TRANS/WP.29/1005
7 April 2004

DRAFT SUPPLEMENT 4 TO REGULATION No. 65

(Special warning lamps)

Examples of approval marks, amend to read:

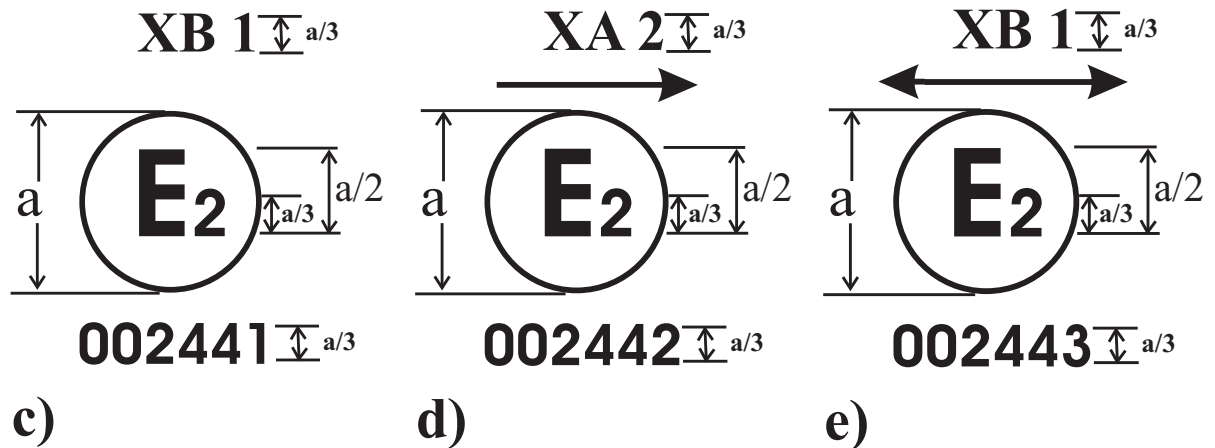
- a) a special warning lamp indicates that it has been approved in the Netherlands (E4) under approval number 002439. The approval number shows that the approval was granted in accordance with the requirements of the Regulation in its original form and that it is a blue rotating or stationary flashing special warning lamp of class 1 (TB 1).
- b) a directional flashing lamp indicates that it has been approved in the Netherlands (E4) under approval number 002440. The approval number shows that the approval was granted in accordance with the requirements of the Regulation in its original form and that it is a amber rotating or stationary flashing special warning lamp of class 2 (TA 2)."

- c) a directional flashing lamp indicates that it has been approved in France (E2) under approval number 002441. The approval number shows that the approval was granted in accordance with the requirements of the Regulation in its original form and that it is a blue directional flashing lamp of class 1 (XB 1).

The marking without an arrow indicates that the lamp has a narrow-angle effect.

- d) a directional flashing lamp indicates that it has been approved in France (E2) under approval number 002442. The approval number shows that the approval was granted in accordance with the requirements of the Regulation in its original form and that it is a amber directional flashing lamp of class 2 (XA 2).

The arrow indicates that the lamp has a wide-angle effect on the side indicated by the direction in which the arrow is pointing, which also indicates the side of the vehicle on which the device is to be mounted.

- e) a directional flashing lamp indicates that it has been approved in France (E2) under approval number 002443. The approval number shows that the approval was granted in accordance with the requirements of the Regulation in its original form and that it is a blue directional flashing lamp of class 1 (XB 1).

The double side arrow indicates that the lamp has a wide-angle effect to both sides, which also indicates that the lamp could be mounted on both side of the vehicle.

7.3.1. Table of standard light distribution for special warning flash lamp (Category X)

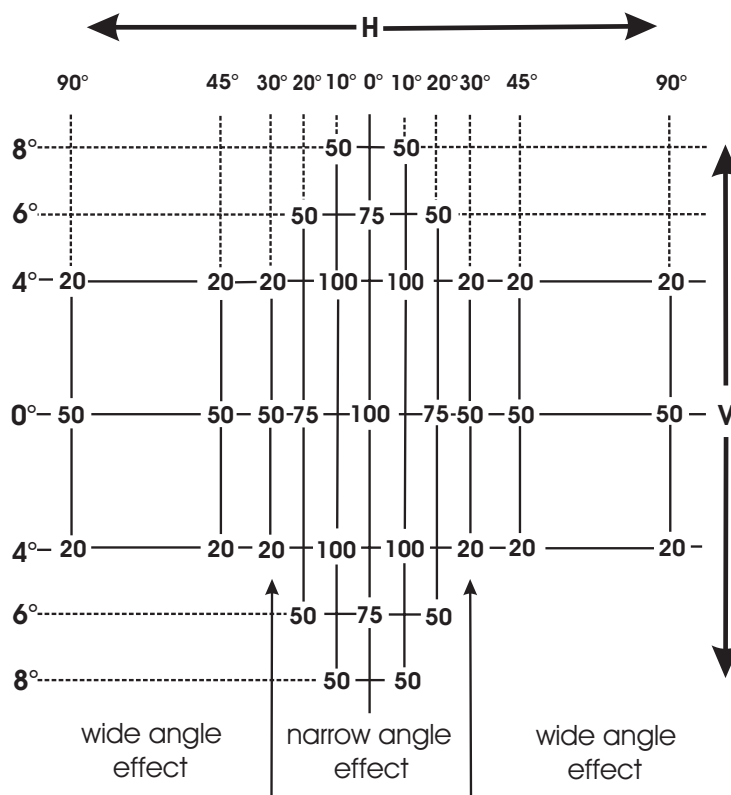
Minimum horizontal angular range of category "narrow angle effect" is 30° left to 30° right and for category "wide angle effect" 90° directed outwards the vehicle and 30° to the inside.

- 7.3.1.1. The direction $H = 0^\circ$ and $V = 0^\circ$ corresponds to the reference axis. (On the vehicle it is horizontal, parallel to the median longitudinal plane of the vehicle and oriented in the required direction of visibility). It passes through the centre of reference. The values shown in the table give, for the various directions of measurements, the minimum intensities as a percentage of the minimum required in the axis for each lamp (in the direction $H = 0^\circ$ and $V = 0^\circ$).
- 7.3.1.2. Within the field of light distribution of paragraph 7.3.1. schematically shown as a grid, the light pattern should be substantially uniform, i.e. the light intensity in each direction of lowest minimum value being shown on the grid lines surrounding the questioned direction as a percentage."
